ADDENDUM #1

City of Berea Restroom

BG 24-016

DATE: September 23rd, 2025

2 BUILDING SECTION - TRANSVERSE
3/8" = 1'-0"

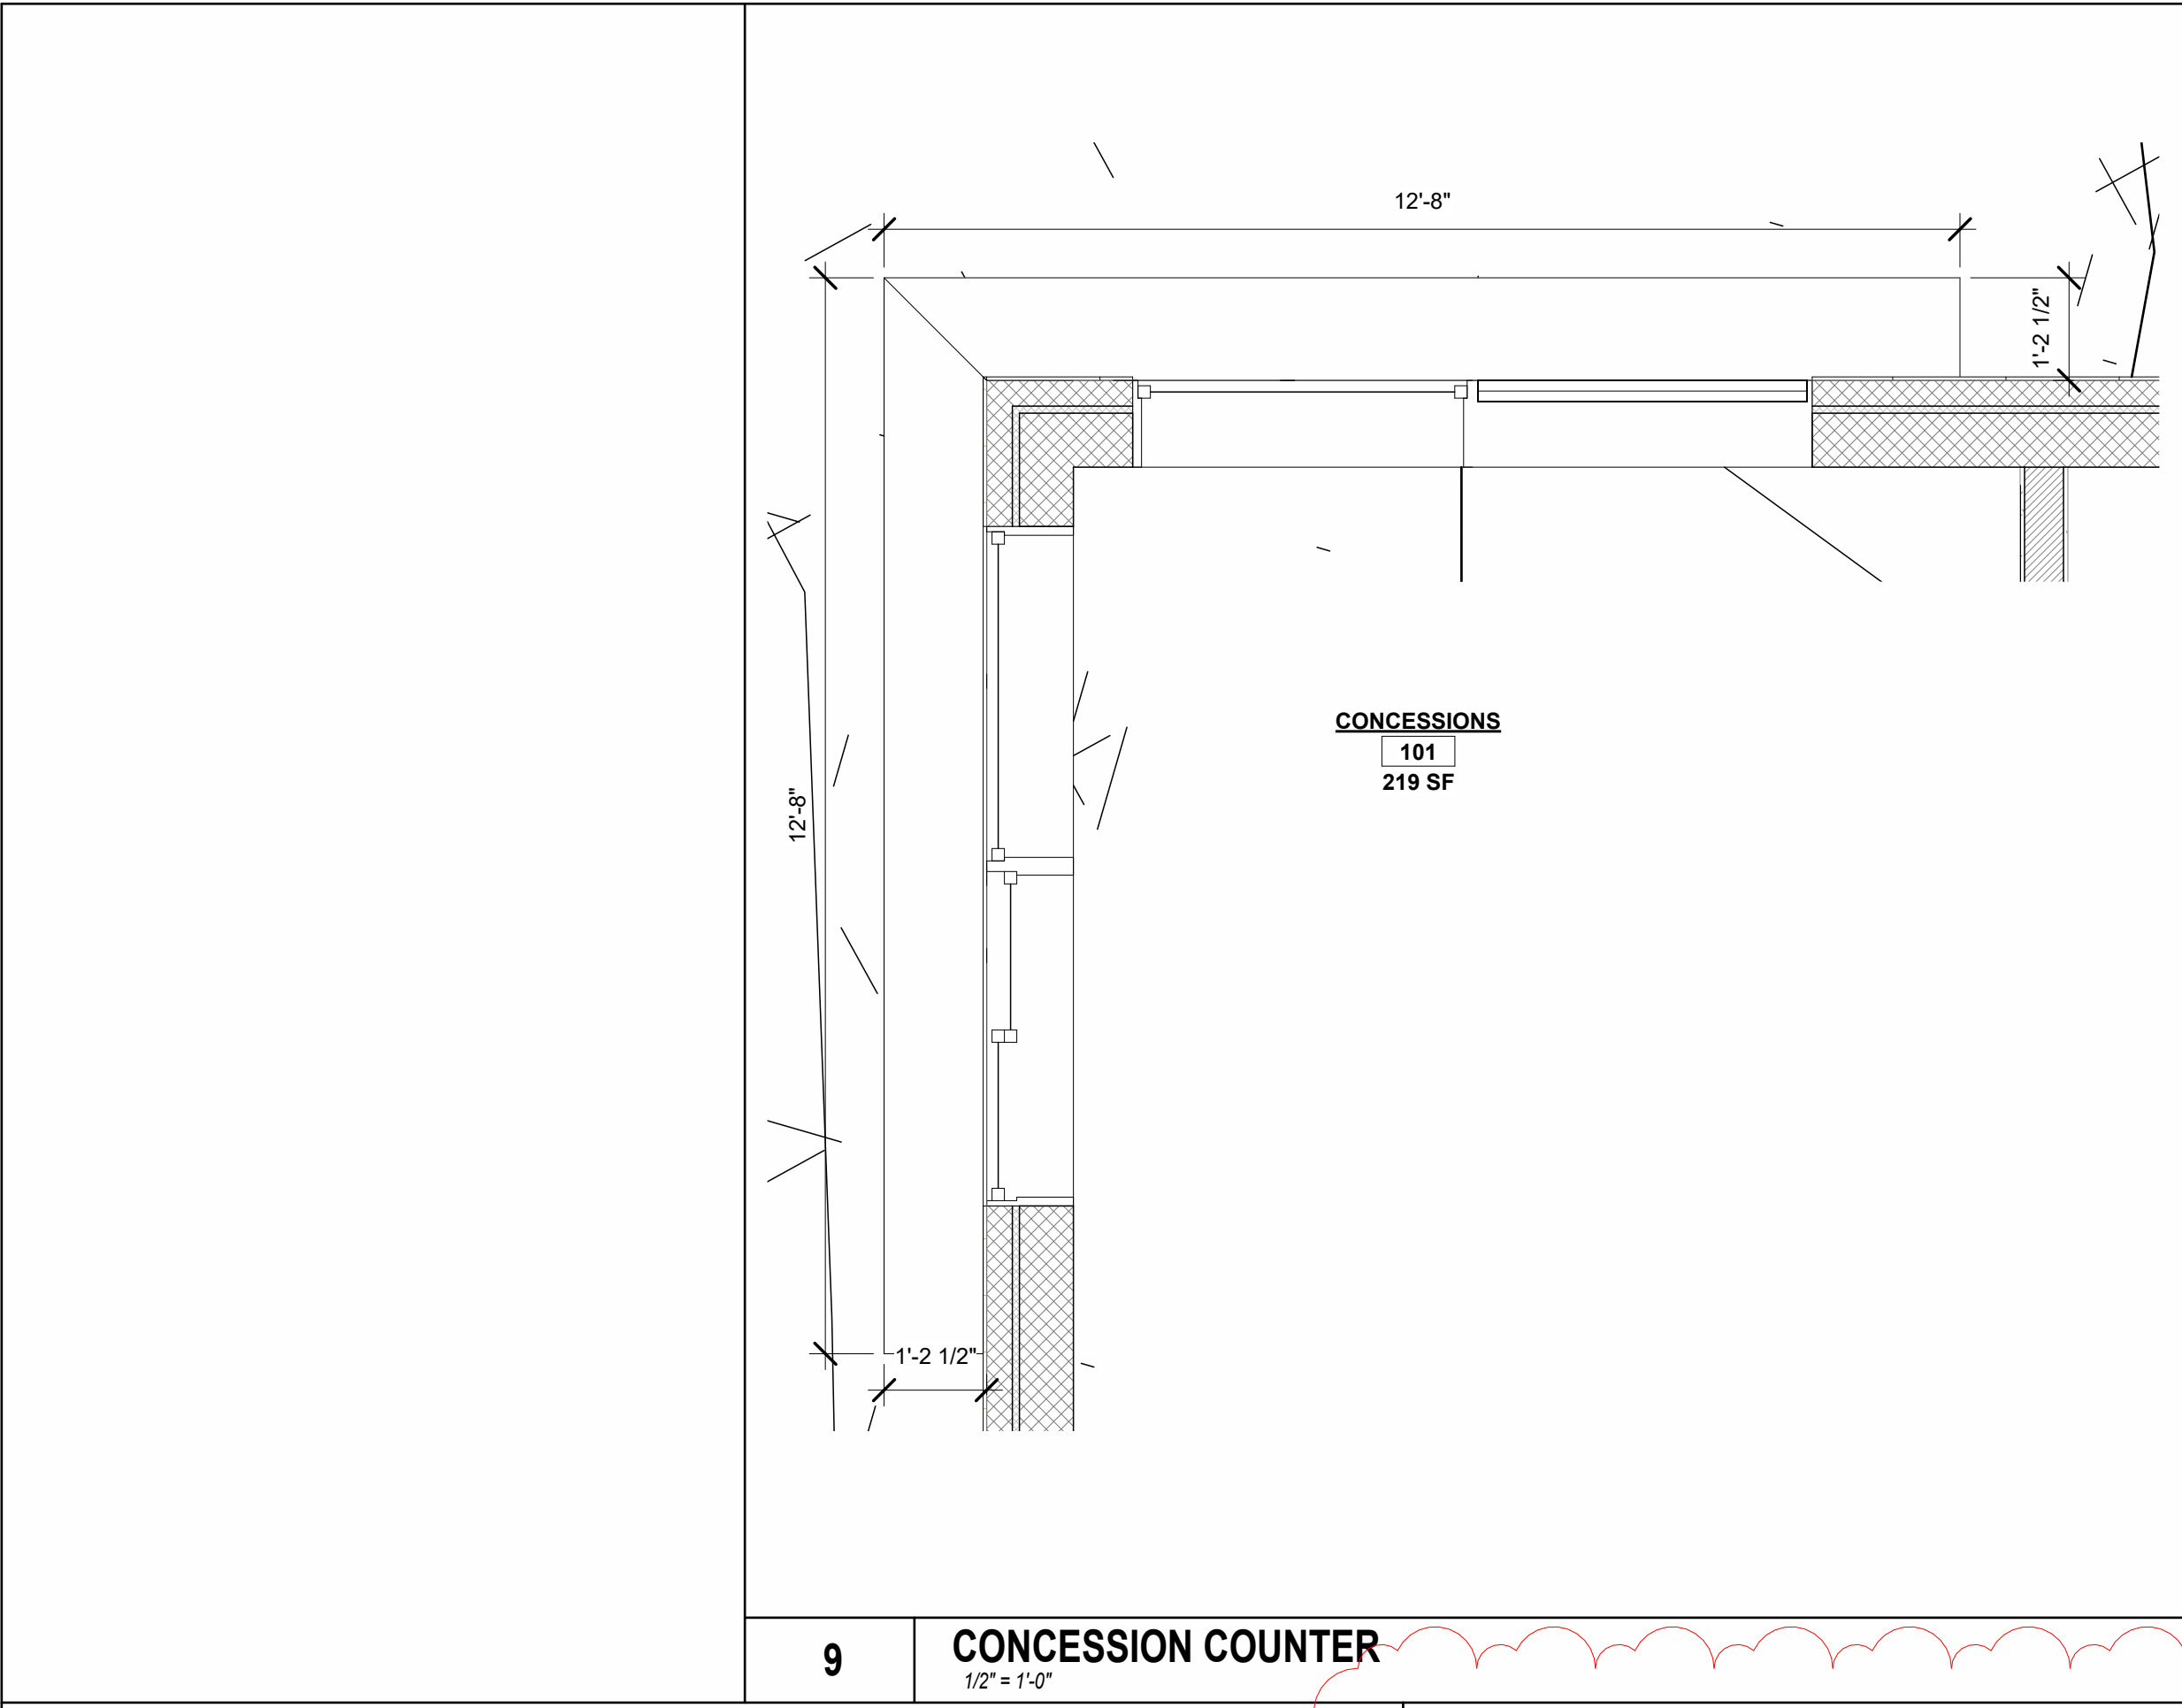
- a. Building Section – Transverse now shows 6" CMU BEARING WALL WITH 8" STEM WALL
- 13. Refer to attached sheet A301; Wall Sections & Details
 - a. Soffit Detail now shows: 8" CMU BOND BEAM

1 EXTERIOR WALL SECTION
3/4" = 1'-0"

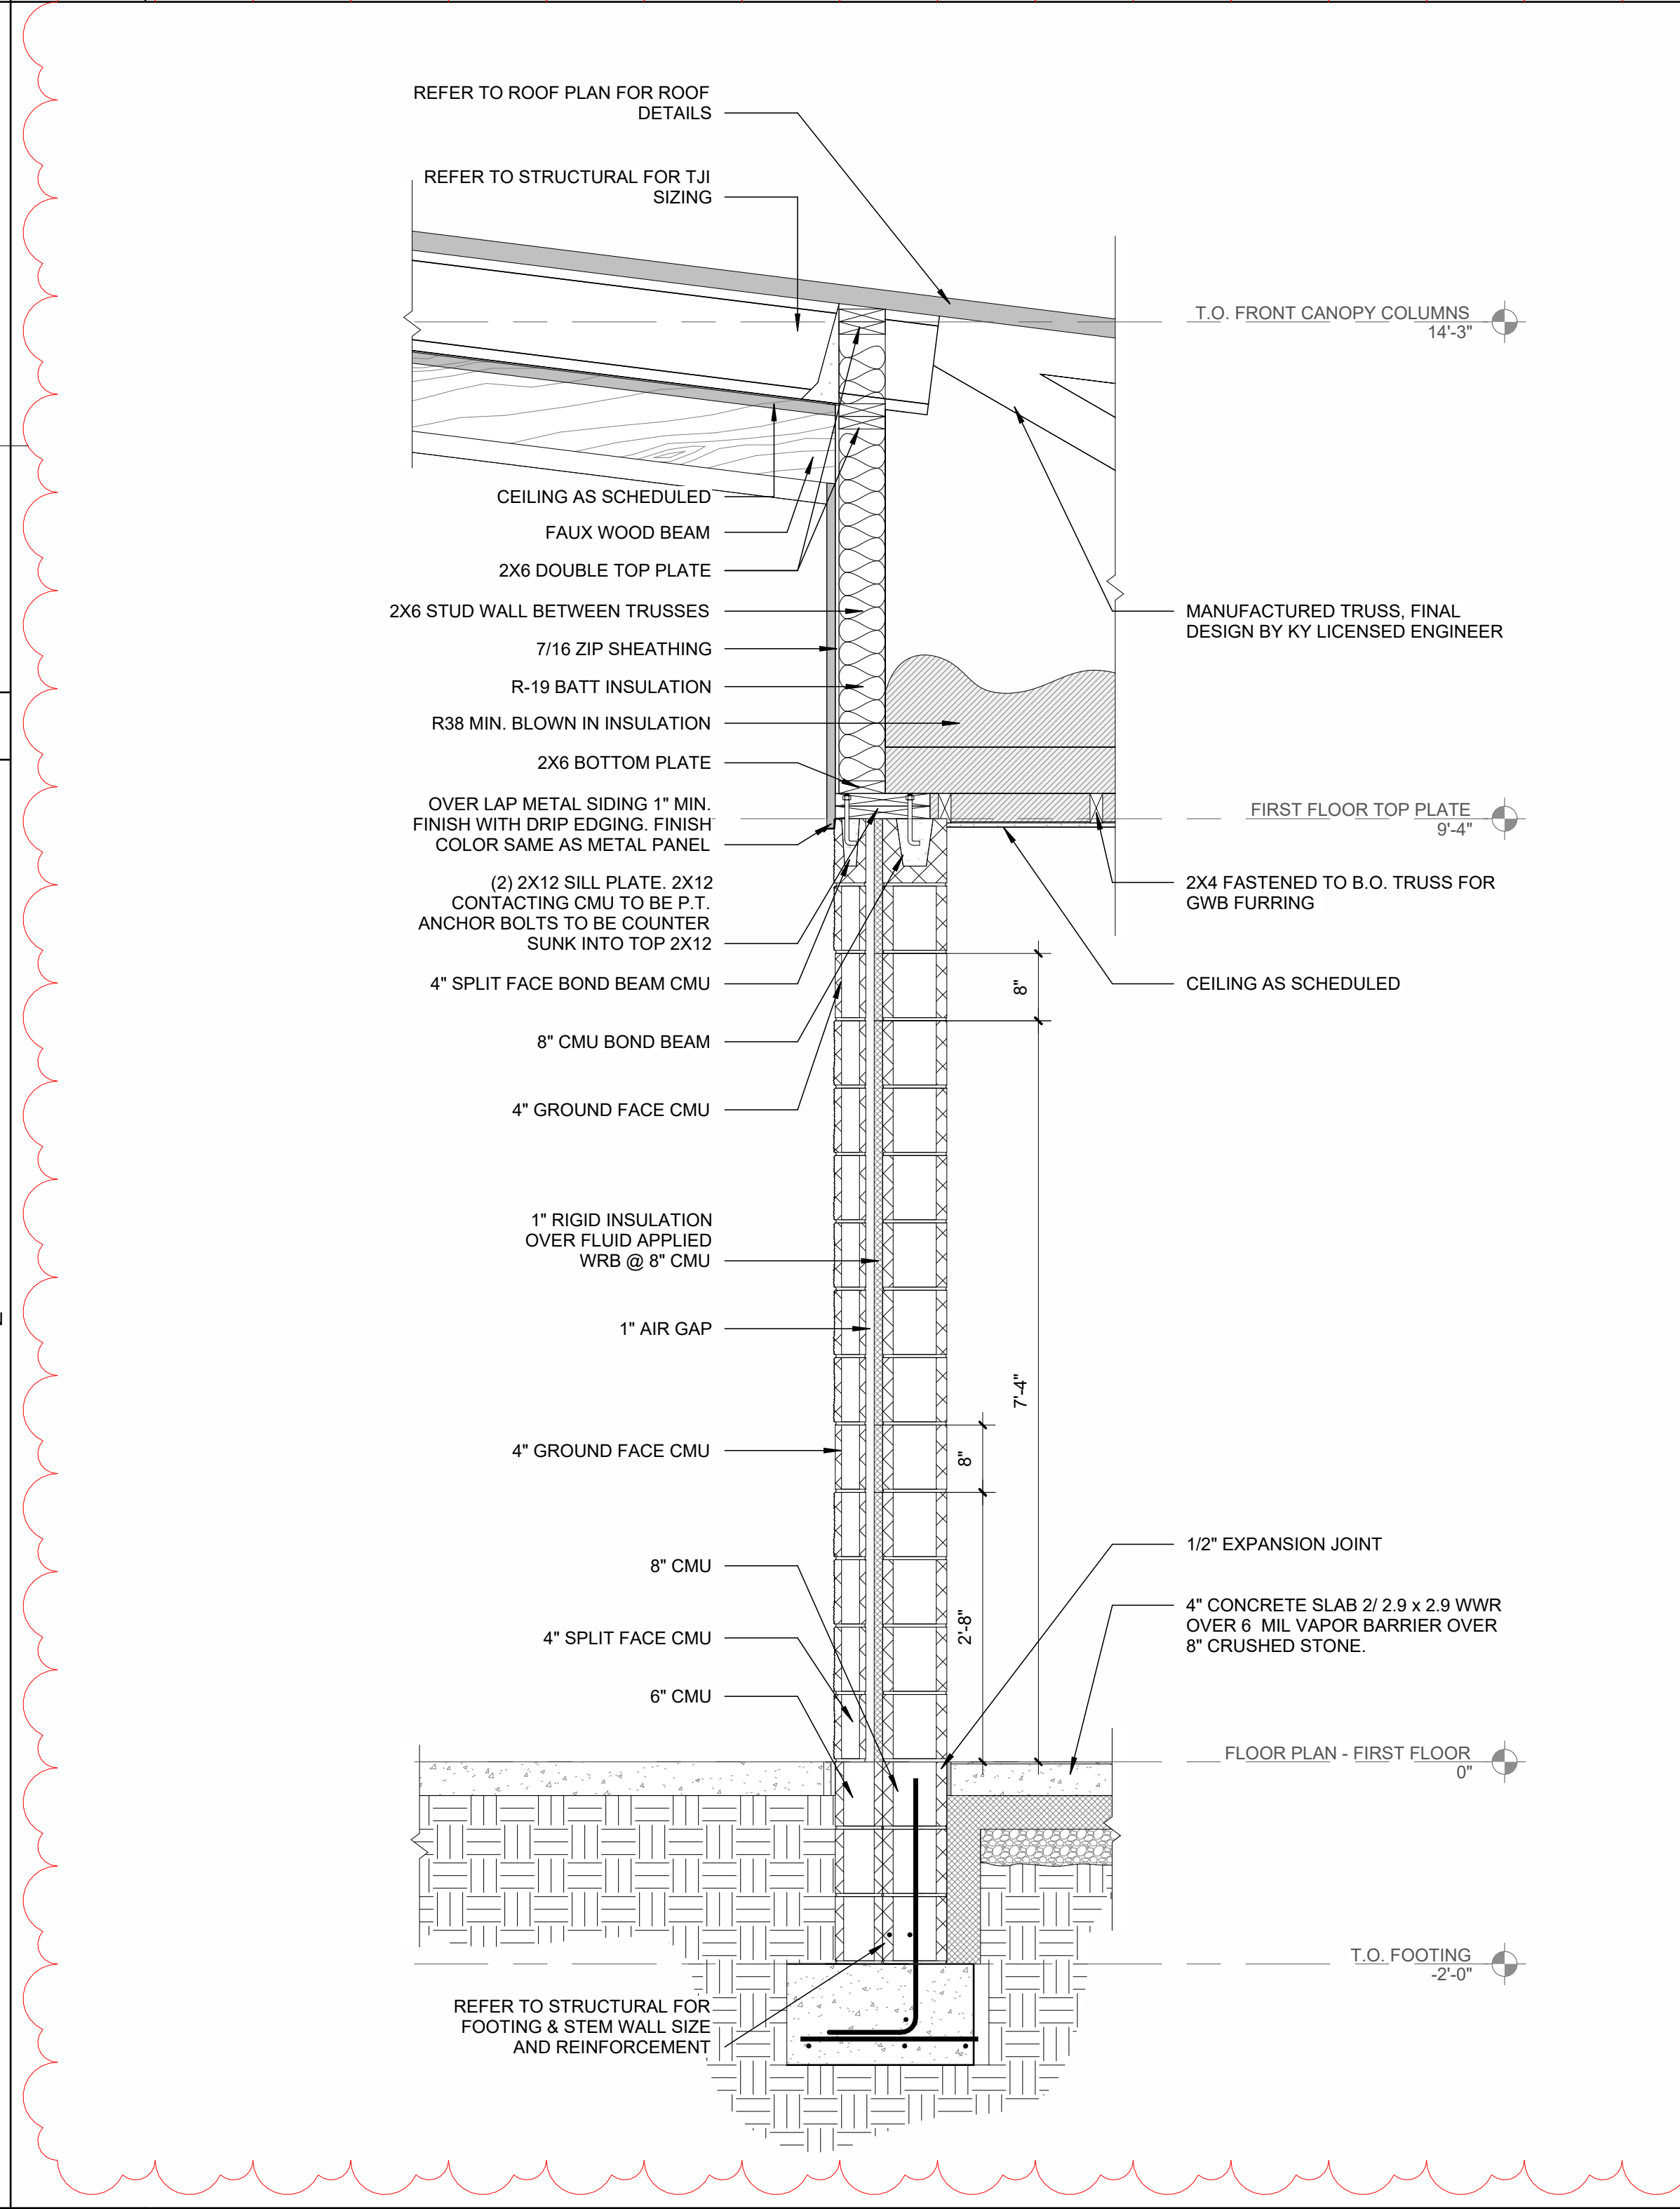
- 14. Refer to attached sheet A301; Wall Sections & Details – EXTERIOR WALL SECTION
 - a. See revised text changes.

1 ELECTRICAL - LIGHTING PLAN

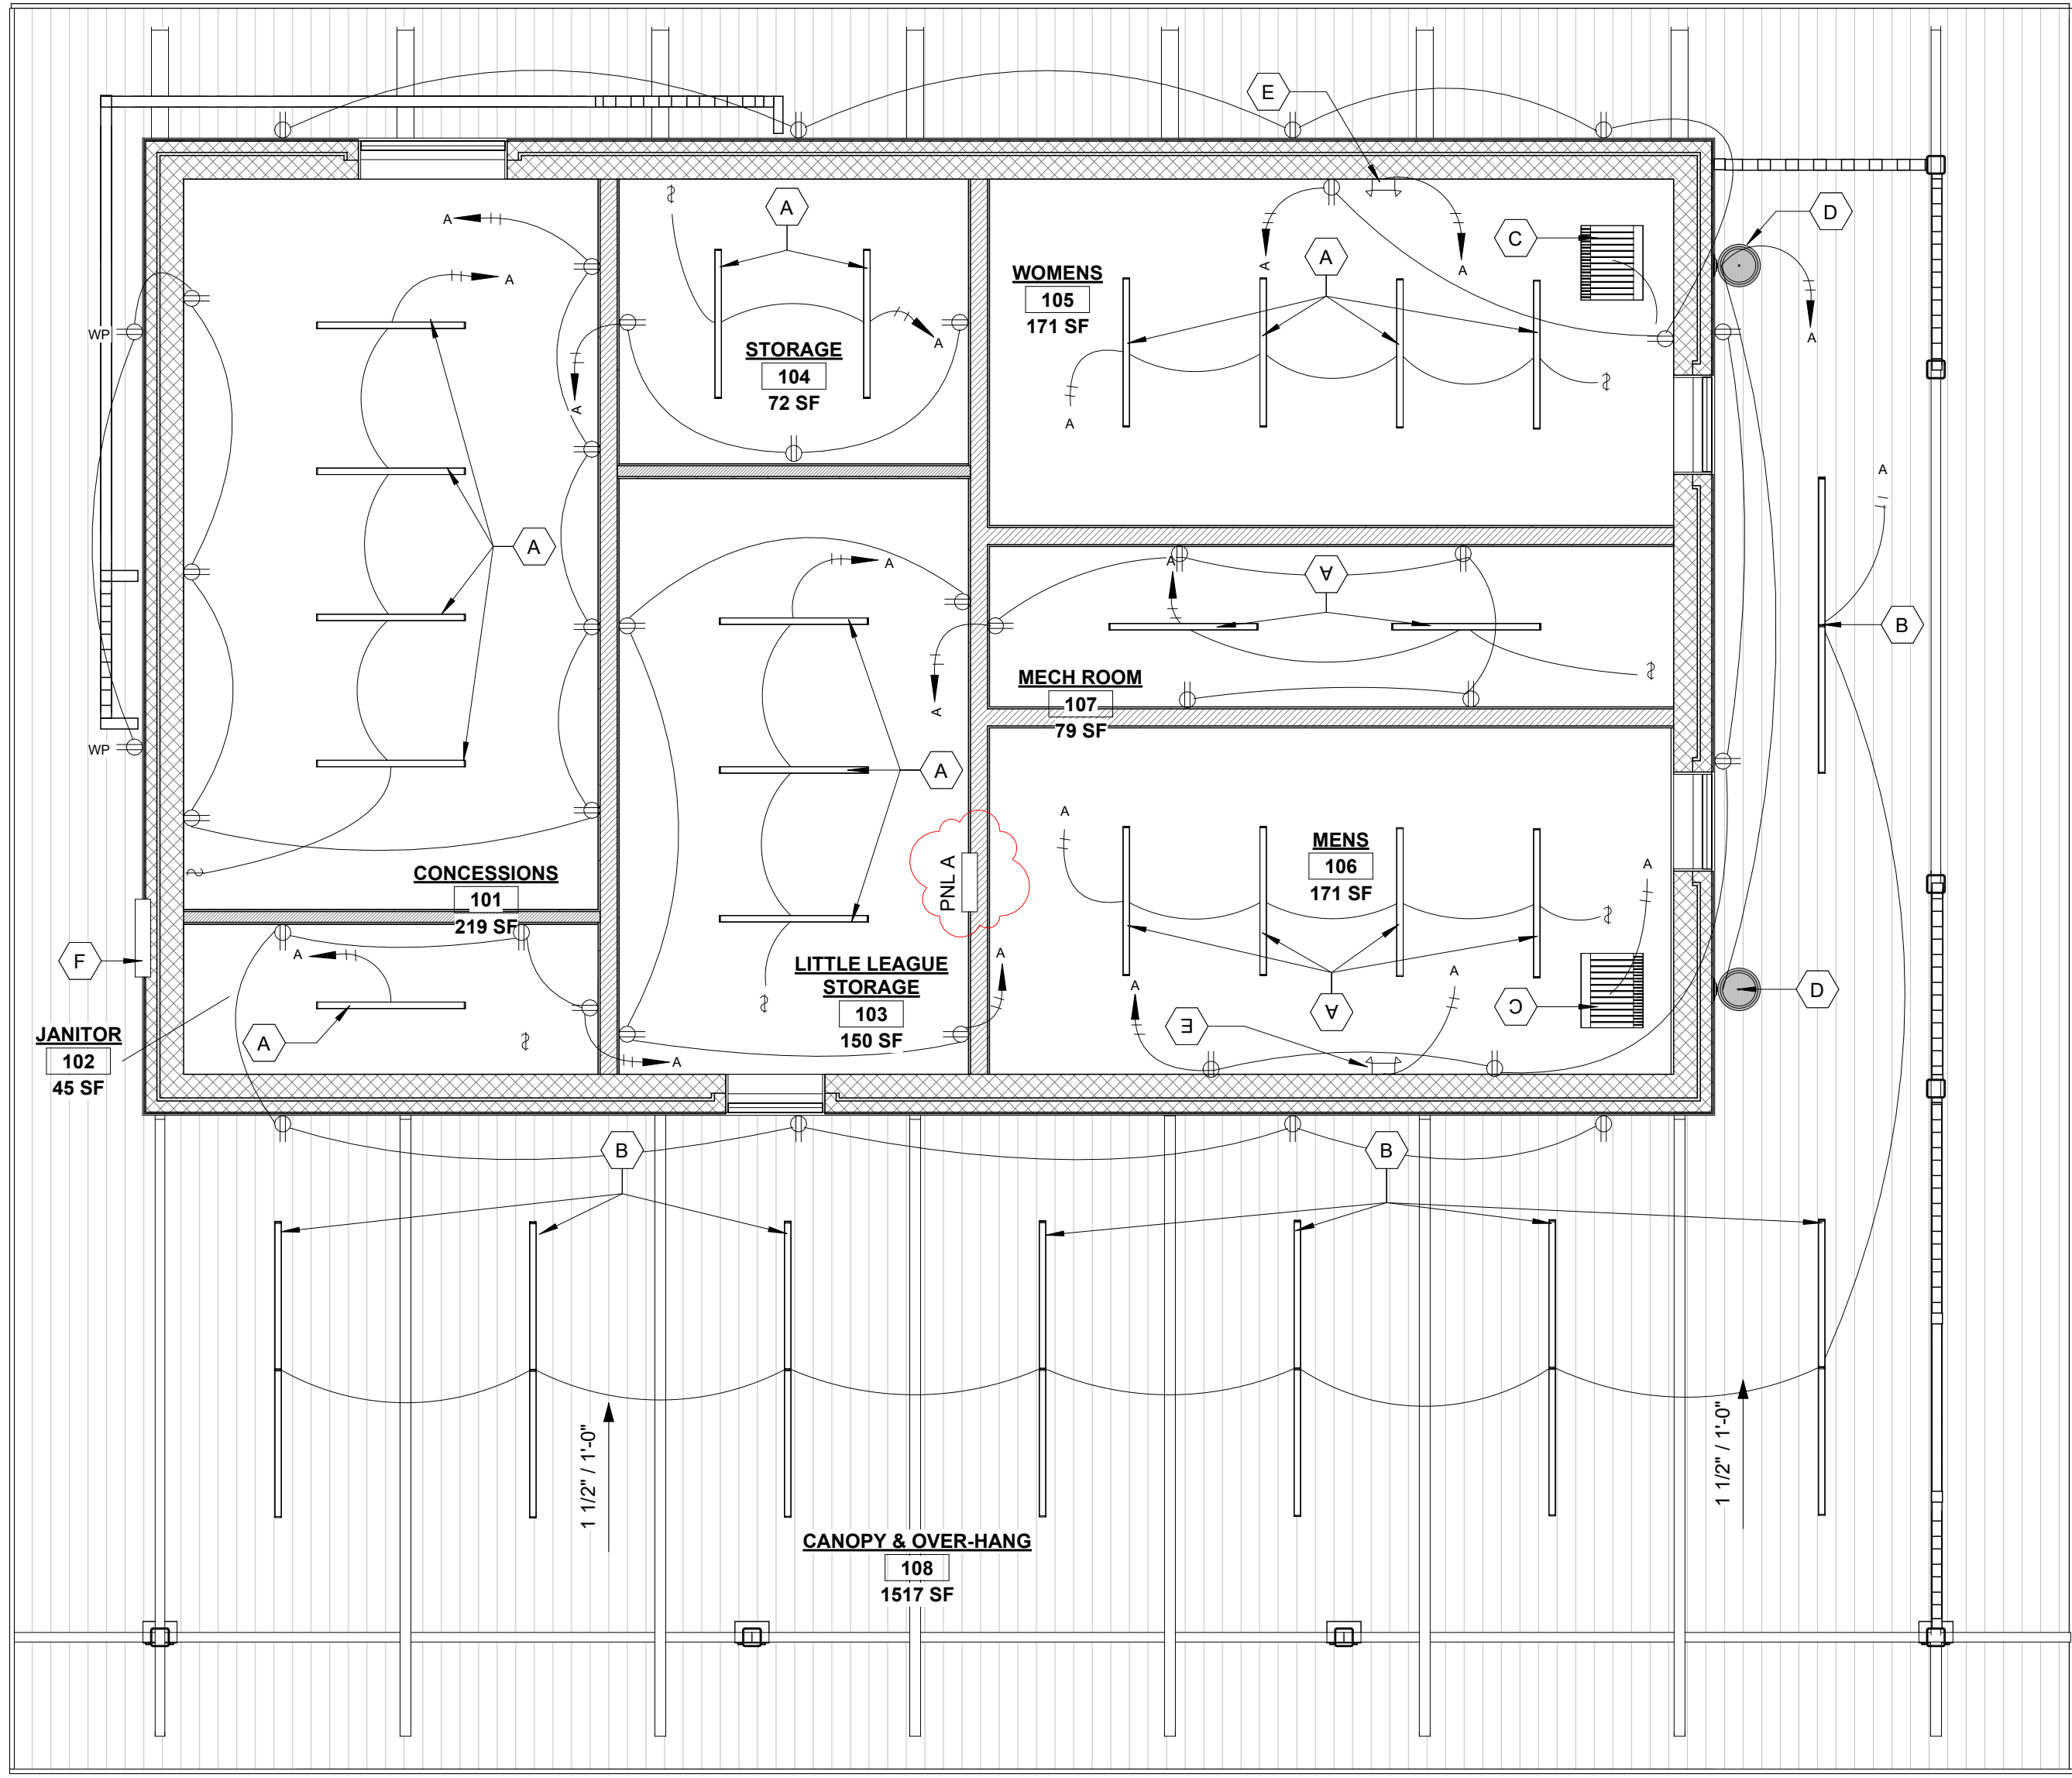
- a. Sheet note 4 will now read: 8" X 16" LOUVER W/ INSECT SCREEN & 100 CFM EXHAUST FAN, INTERNAL 2YU46 THERMOSTAT ACCESSORY.
- 6. Refer to attached sheet E100; Electrical Plan

- a. Plan will now show electrical outlet layout
- 7. Refer to attached sheet E100; Electrical Plan
 - a. Plan will now show water heater equipment information.

ADDENDUM 1, ITEM 6

ADDENDUM 1, ITEM 7

WATER HEATER EQUIPMENT

SYMBOL	EQUIPMENT	CAPACITY	GPM	AMPS	PHASE-VOLTS
WH1	RHEEM-RUDD ES120-18-G	18KW	106 GPH RECOV	75	1/240/60
